**REQUEST FOR EXCEPTION TO
RAPID CITY DESIGN STANDARD AND CRITERIA**

PROJECT 1321 Mt. Rushmore Road
DATE: 10.26.06 SUBMITTED BY: Roger Baker 6 Fairmont Blvd
PIN #: 3702430025 W- 343-9559 H- 716-3765
LEGAL DESCRIPTION: E 114.1' of LOT 21 WEST BOULEVARD.

EXCEPTION REQUESTED: SECTION 8.2.1 STANDARD/CRITERIA STREET CRITERIA MANUAL
DESCRIPTION OF REQUEST: to PAVE RIGHT-OF-WAY FOR PARKING.

RE: Appeal of the Denial of the Request for Exception to Pave the Right-of-way for Parking at 1321 Mt. Rushmore Road

1321 Mt. Rushmore Road

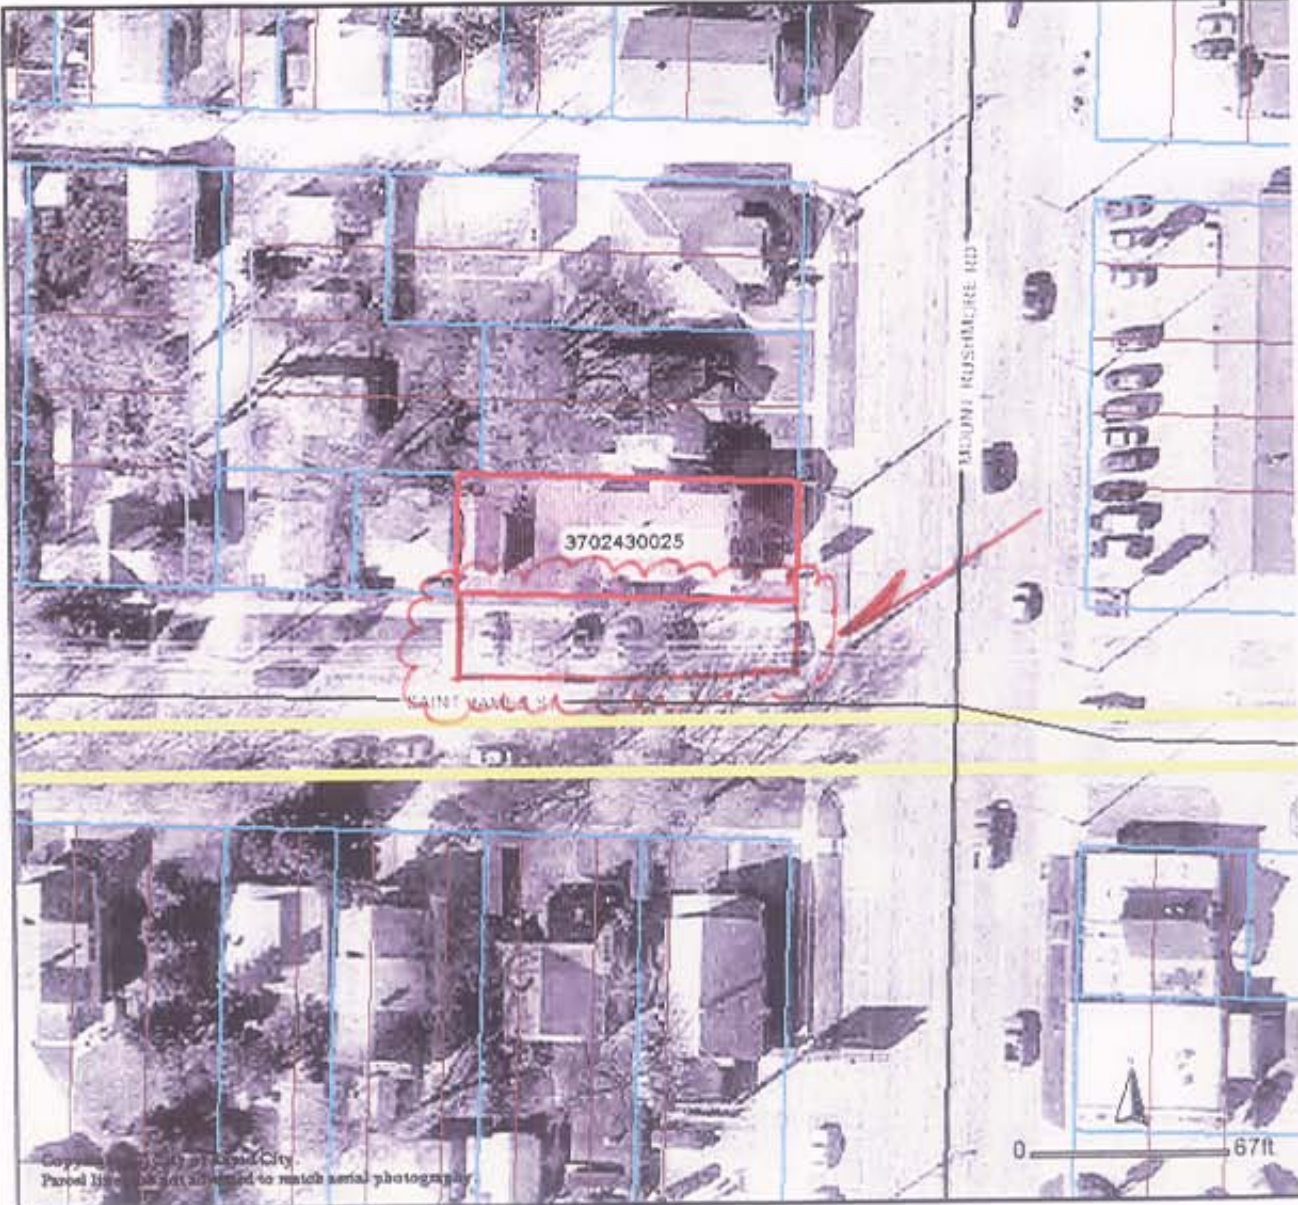
STAFF RECOMMENDATION: To deny as it violates 8.2.1 G of The Street design criteria manual

- The applicant was granted a variance to reduce the number of off-street parking spaces from 16 to 3. To date, the applicant has not provided the required off-street parking spaces nor submitted a building permit for the required parking spaces. Currently the property is being use in violation of the City Ordinance and the approved variance.
- It is likely that once a plan is submitted, the access drive to the required parking area will conflict with a portion of the right-of-way area the applicant is proposing to pave in the right-of-way.
- A portion of the right-of-way area proposed to be paved is in the corner clearance area (85 feet from the corner) which is required to be kept clear of all approaches for safety reasons.
- A small portion of the right-of-way area proposed to be paved appears to be located in the sight distance triangle posing further safety concerns.

Staff Recommendation: Deny the applicant's request without prejudice to allow the applicant to resubmit a site plan and building permit identifying the required off-street parking as allowed pursuant to the variance previously granted.
